Electronic Pressure Relief Valve (EPRV) Delete & Fuel Rail Pressure Sensor Update

Model Years	Models
2018 - 2020	VAH/VHD/VN

EPRV Delete & FRPS Update

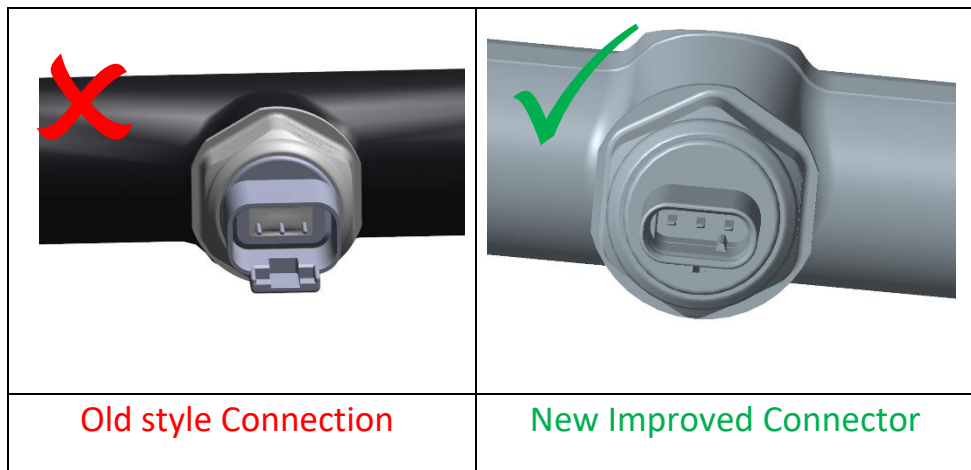
17. A product improvement has been made to the Fuel Rail Pressure Sensor (FRPS) and its wiring harness. A visual inspection of the FRPS electrical connector will indicate which sensor and wiring harness is on the vehicle.

18. Inspect the FRPS, if the Old Style Connector is found (Displayed above with red X), replace the sensor and wiring harness per Impact Instructions listed below. If the New Improved Connector is found, no farther action is needed and proceed to next step.
 - a. 2373-03-03-06 Pressure Sensor, Common Rail, Replacement, Valve Cover Removed
 - b. 2861-03-03-03 Wiring Harness, Injector, Replacement (Rear), Valve Cover Removed
19. Refer to IMPACT document ID: 2115-03-02-02 *Valve Cover, Replacement* for valve cover install procedure.
20. Using PTT Operation 1700-22-03-06 Program accessory kit: **85156014**
Note: Running this kit without removing the ePRV will result in adverse vehicle affects.
